**METROPOLITAN GOVERNMENT OF NASHVILLE AND DAVIDSON COUNTY**

**STAFF RECOMMENDATION**  
**3620 Westbrook Avenue**  
**December 19, 2012**

**Application:** New construction - addition  
**District:** Richland-West End Neighborhood Conservation Zoning Overlay  
**Council District:** 24  
**Map and Parcel Number:** 10405021800  
**Applicant:** Betsy Bergin, Architect  
**Project Lead:** Sean Alexander, sean.alexander@nashville.gov

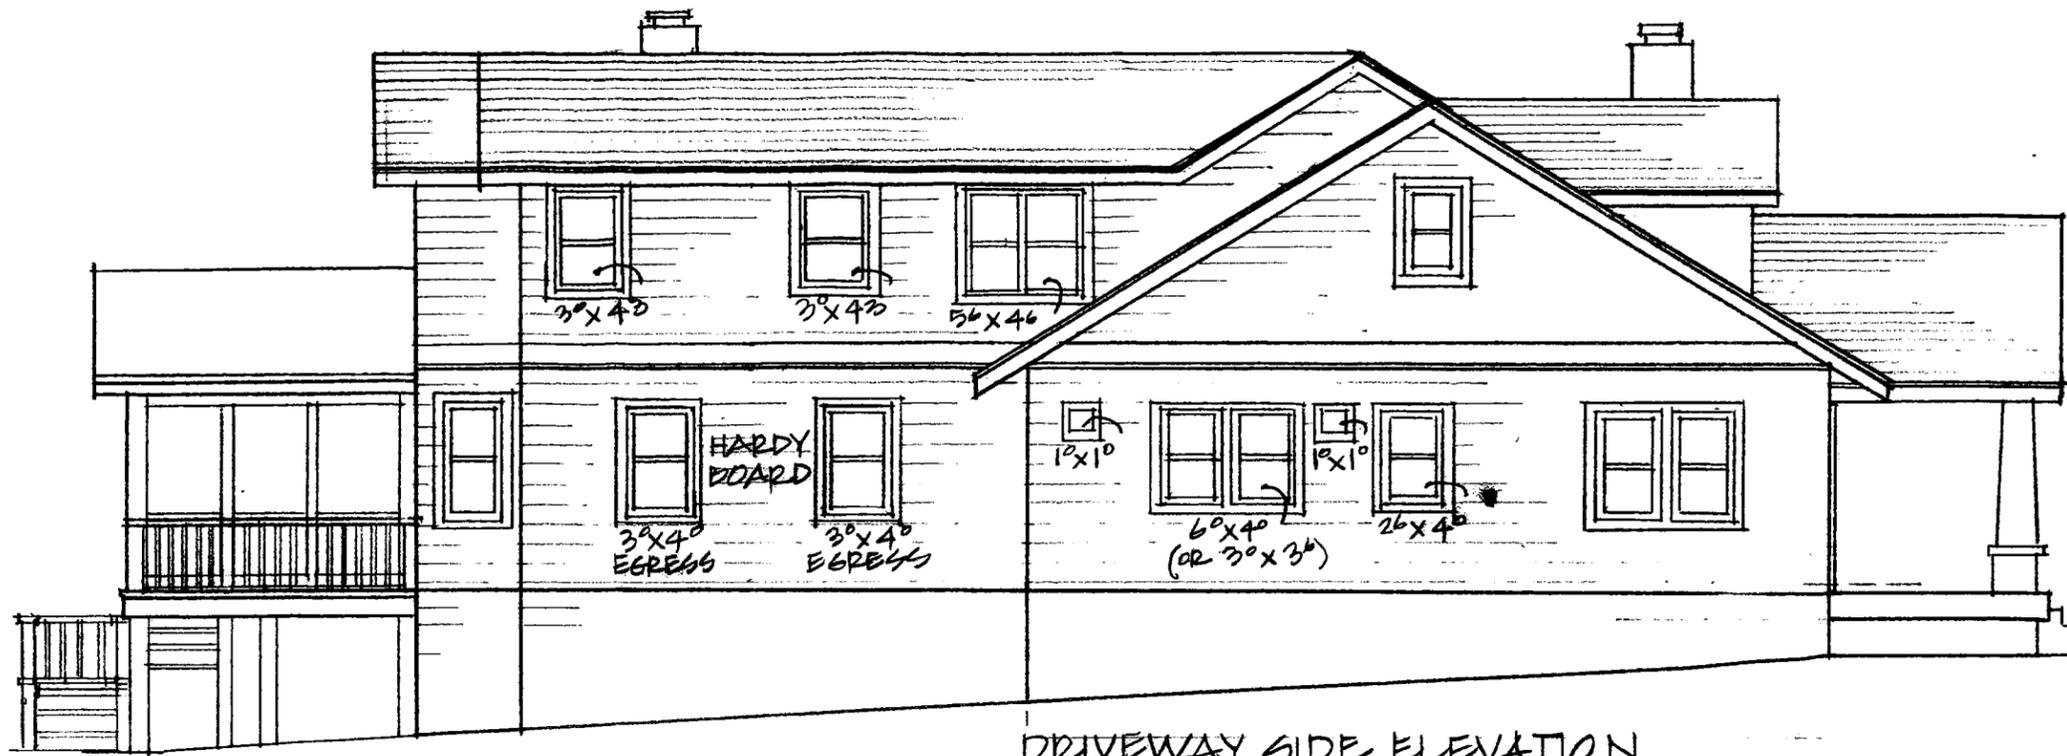
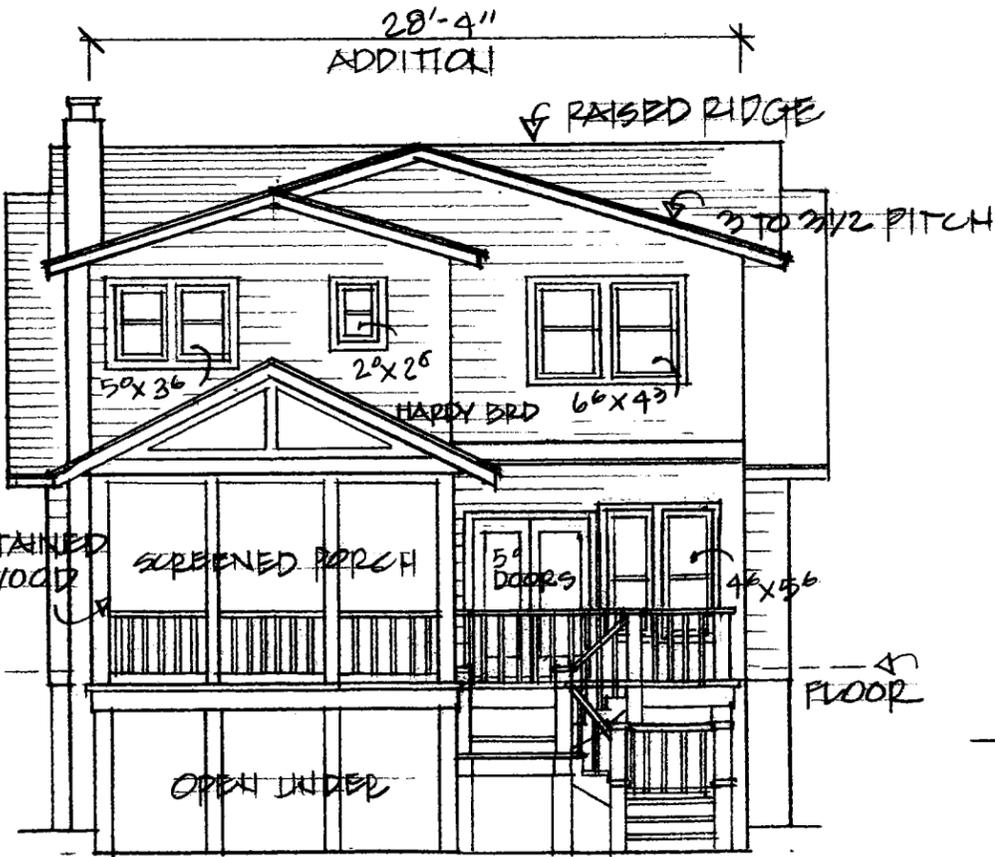
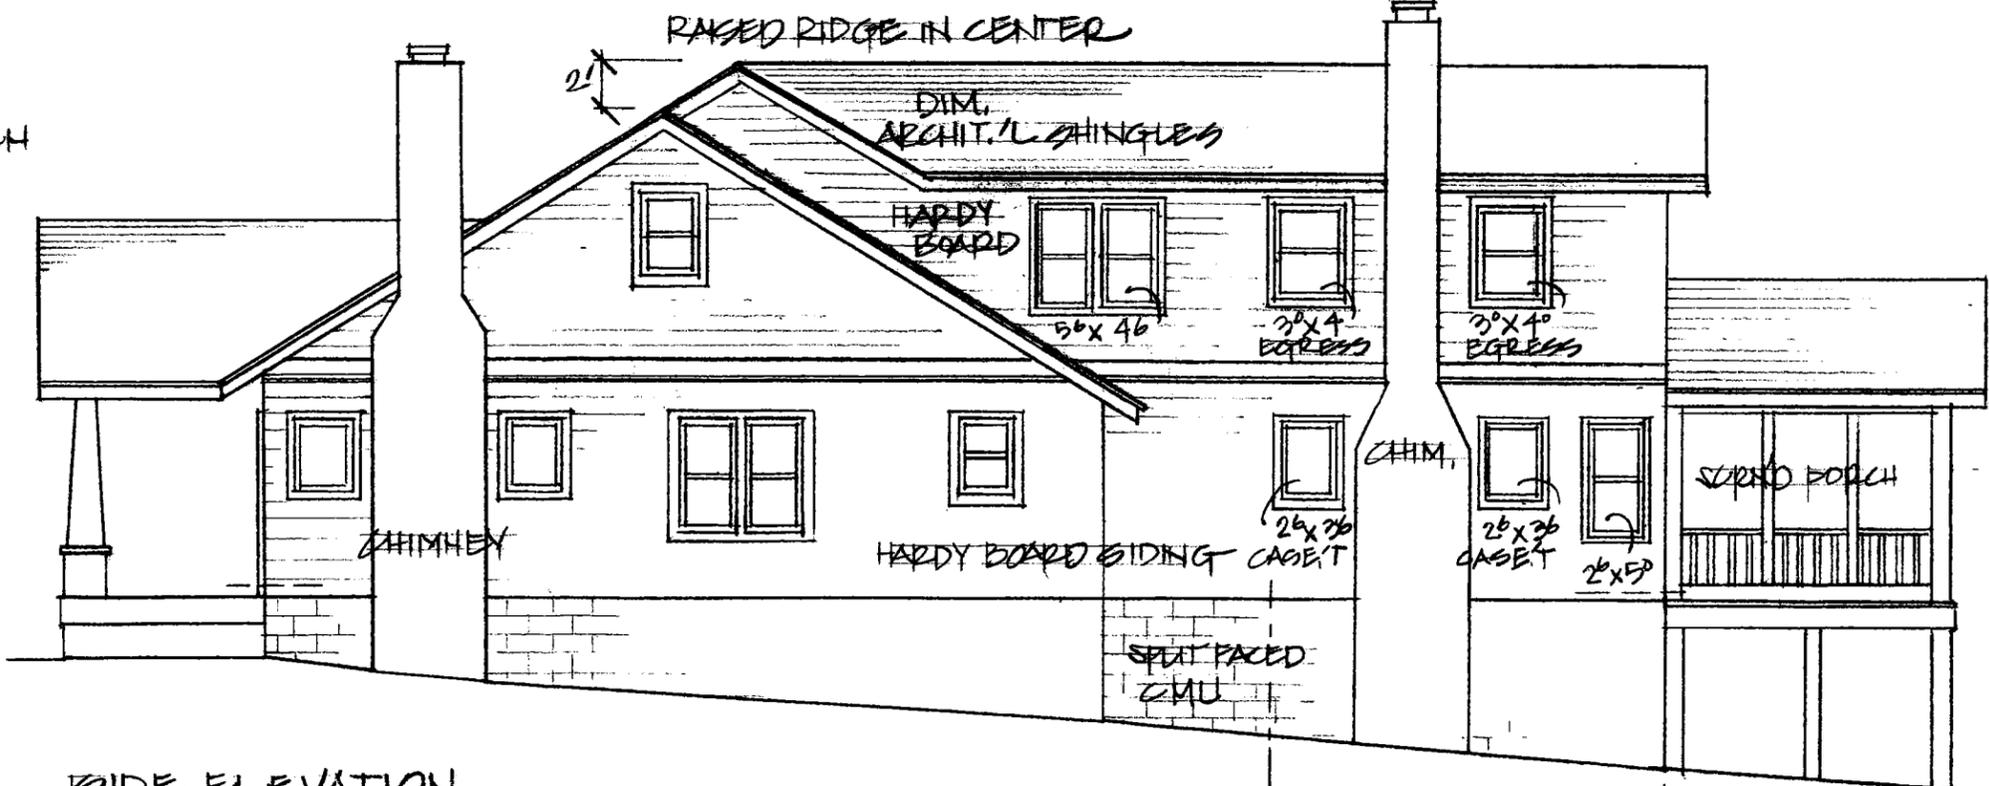
The front slope of the existing roof will be extended up and toward the rear raising the ridge two feet (2') higher, leaving two feet (2') of the existing ridge unaltered on each side of the house. This type of addition has been found by the Commission to be appropriate for side-gabled houses.

A two-story rear addition will be constructed with the side walls setting in two feet (2') from the sides of the house on each side, with a gabled roof intersecting the raised ridge at a "T."

The addition will extend twenty-two feet (22') to the rear on the left side, and twenty-six feet, six inches (26'-6") on the right, which will be subordinate to the historic house. The house is forty-five feet (45') deep, including the front porch. A one story screened porch will further extend the length of the addition twelve-feet, nine inches (12'-9") along the right side. The foundation height and floor levels of the addition will match those of the historic house. Because the addition sets in from the sides of the historic house and will be no taller than the raised ridge, it will not disturb the form of the historic house and will not have a significant impact on its appearance from the right of way. Staff finds the height and scale of the addition to meet guidelines II.B.1.a. and II.B.1.b.

The exterior of the addition will be clad with smooth-faced cement-fiber siding matching the exposure of the siding on the house. The windows, window casings, and other trim will be wood. The foundation will be split-faced concrete block and the roof will be gray composite shingles. There will be a brick chimney on the left side, matching a brick chimney on the historic house. Staff finds these materials to be compatible with those of the house and to meet guideline II.B.1.d.

The window patterns on the sides of the addition will maintain the rhythm of openings on the historic house, with windows compatible in proportion to those on the house as well. The addition will meet guideline II.B.1.g.

Staff recommends approval of the ridge raise and rear addition, finding it to meet the guidelines for new construction and additions in the Richland-West End Neighborhood Conservation Zoning Overlay.
